SHOP DRAWING TRANSMITTAL

Project: Turnbull School Music Room Addition Project No: 1705
Date: November 12, 2018
To: TALCO Building Innovations Ltd.
Attn: Farah Bano (fbano@tal-co.com)
From: Michelle Cataldo

Shop Drawing Submittal: Division 05 - Metals
Submitted by: Fortran Steel Contracting Ltd.
Drawing Title: Guardrail at Retaining Wall
Revision No. N/A
Dated: 9/11/18
Comments:
Reviewed as noted.

DWG. TITLE: GUARDRAIL@RETAINING WALL
 DRAWN BY: YANG DATE: 01/30/2017 JOB NUMBER: 19-18 DWG NUMBER: M01

GUARDRAIL@ RETAINING WALL PLAN VIEW

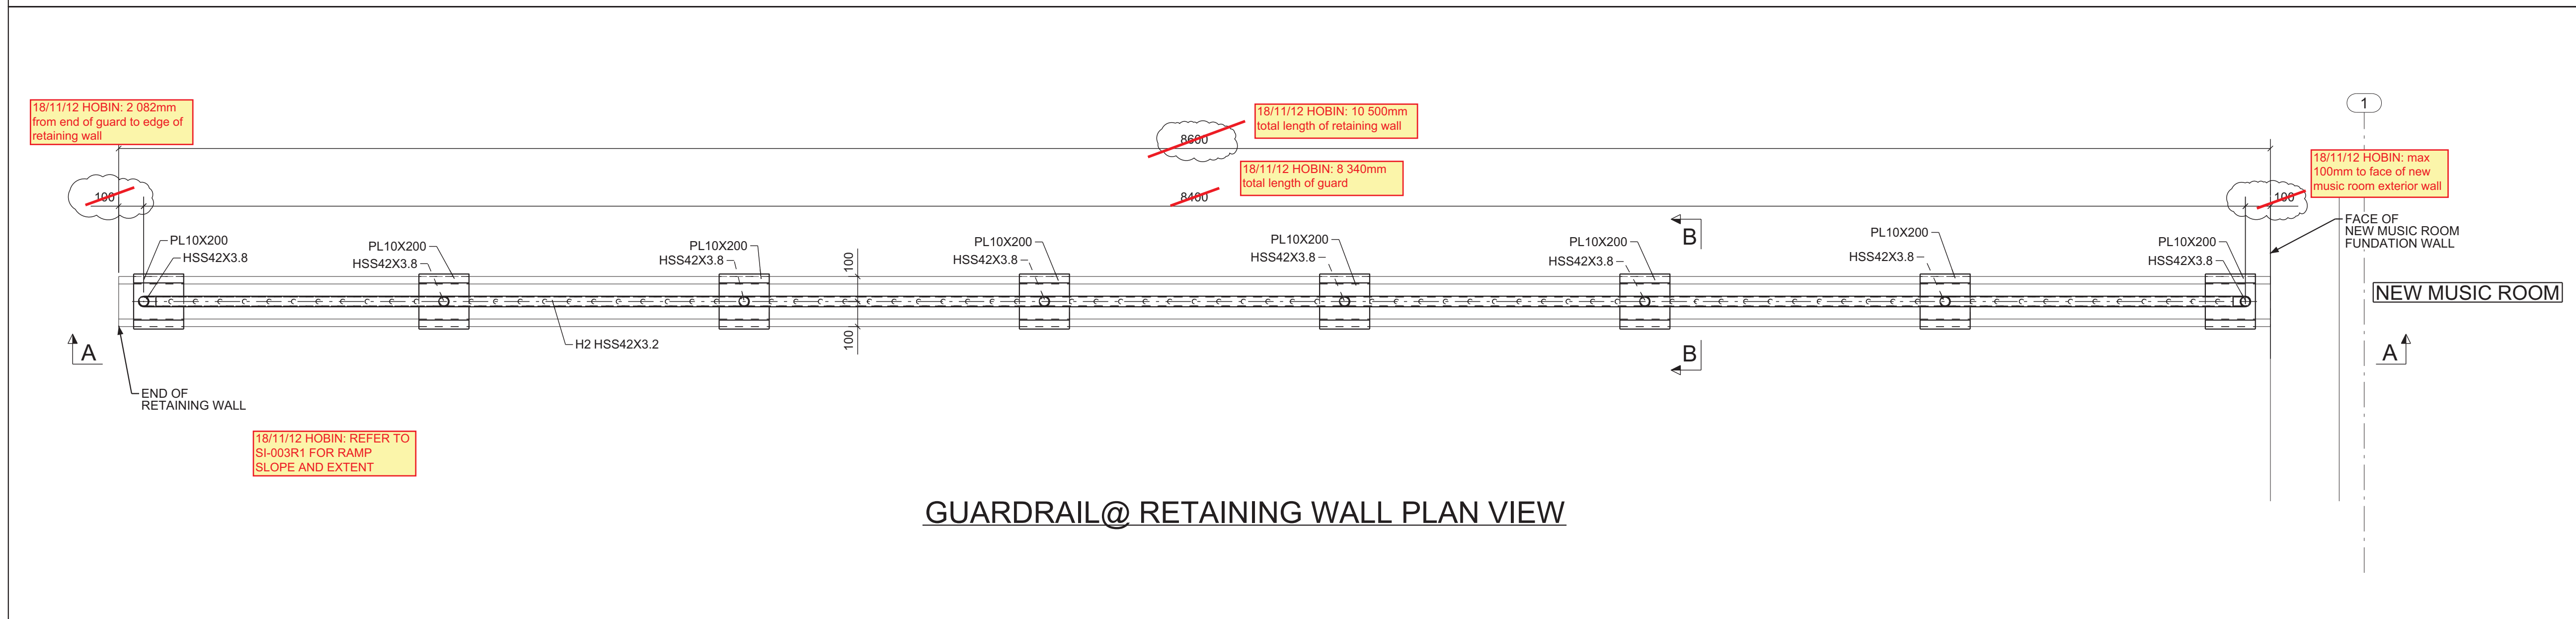
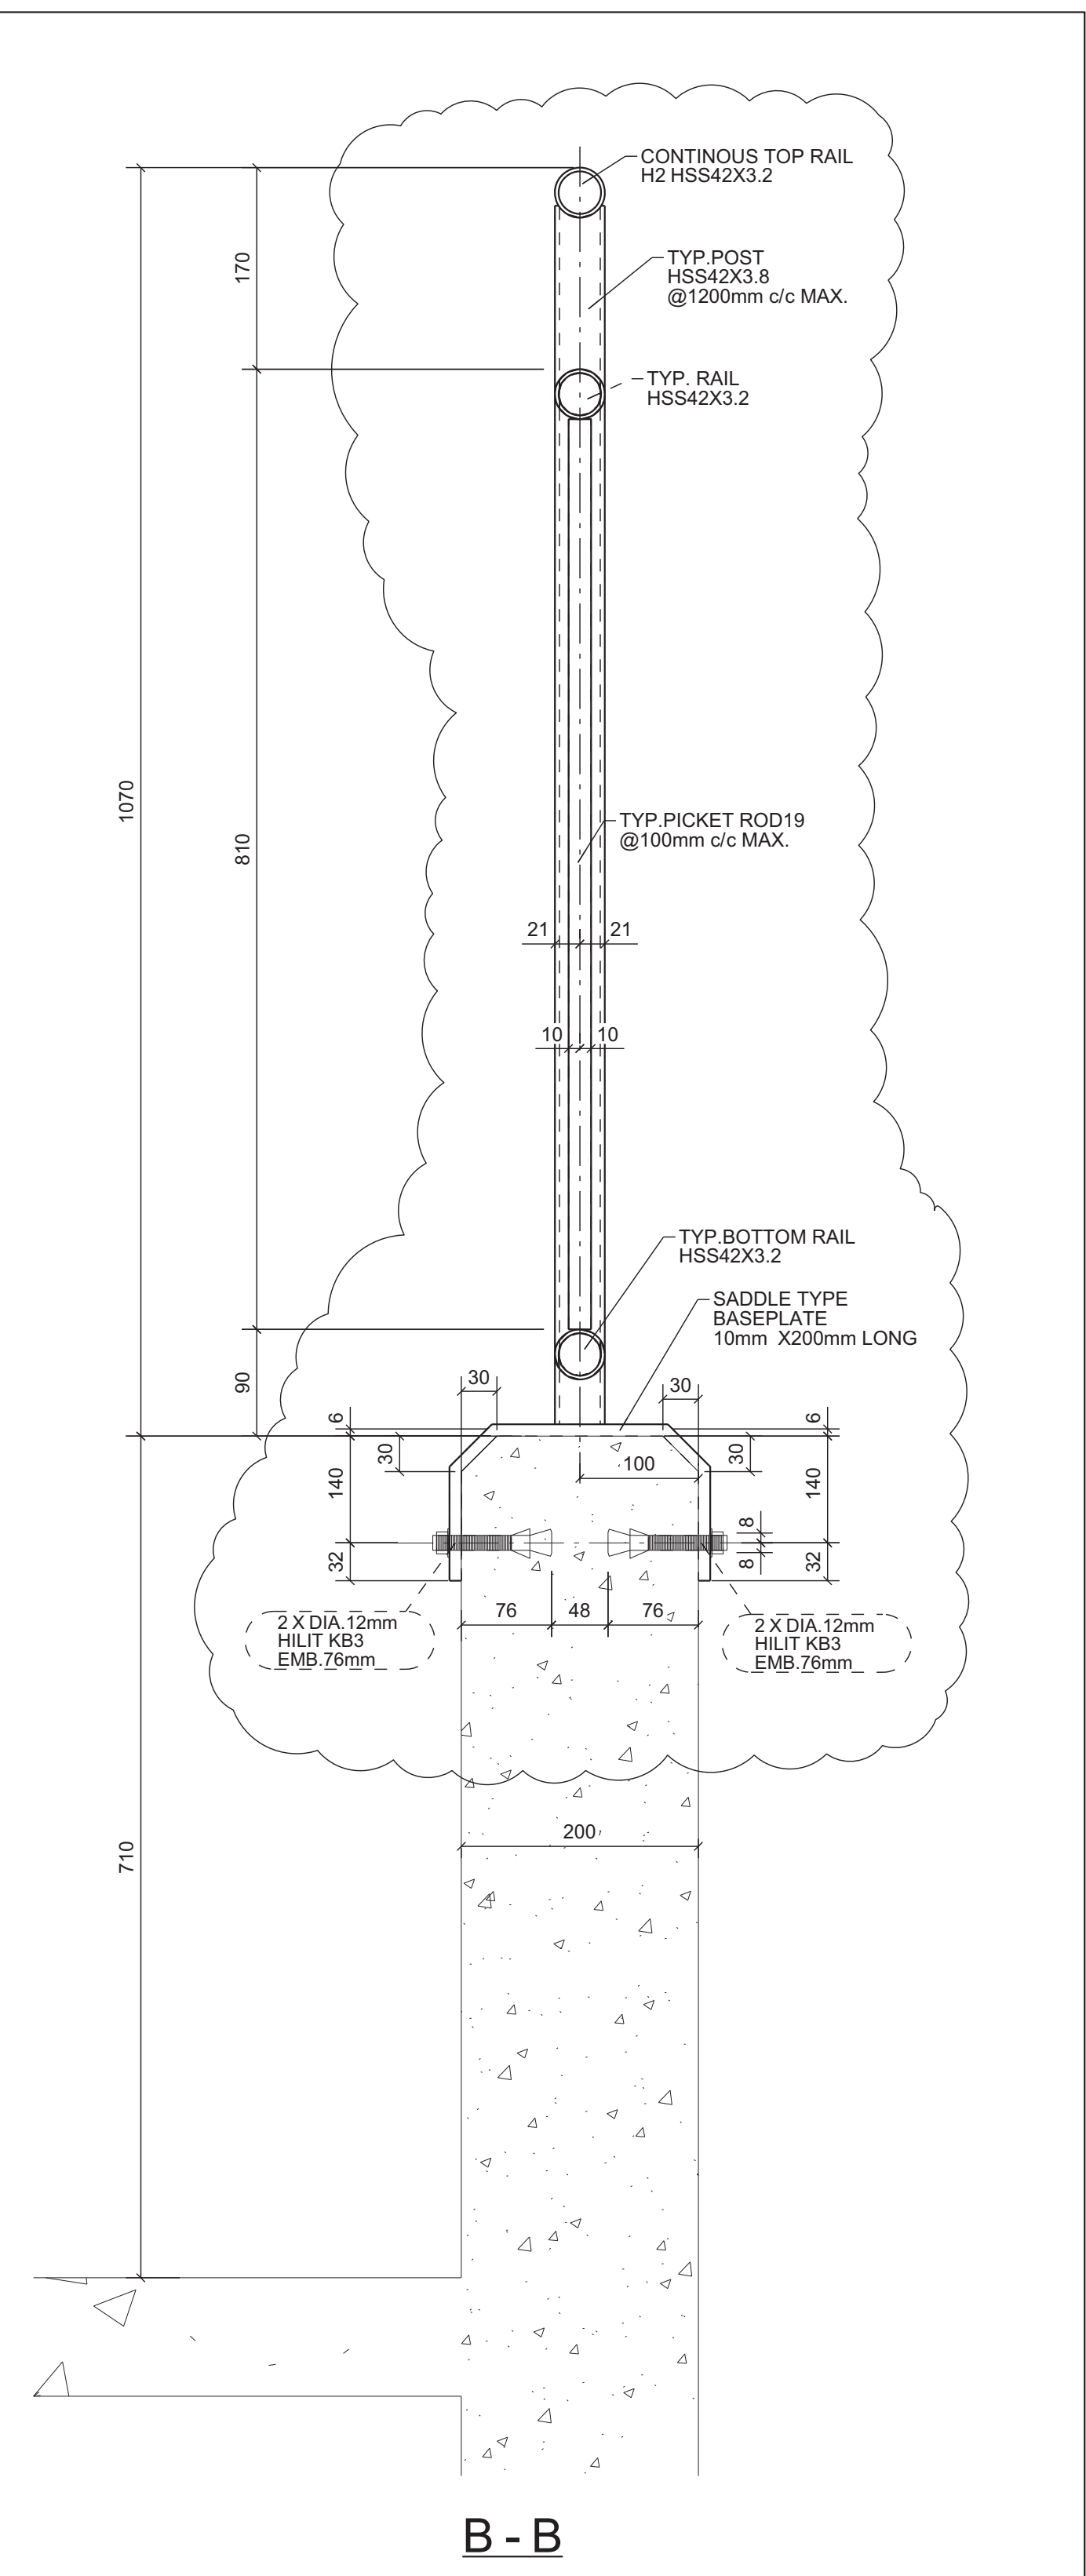
PLEASE CONFIRM ALL THE DIMENSIONS AND DETAILS

TBI Comment:
 Tender Addendum A02, item #3.01 asks for length of guardrail to match length of landing at the bottom of the +/- 6.4m-ramp.
 Hobin to clarify/confirm final guardrail length.
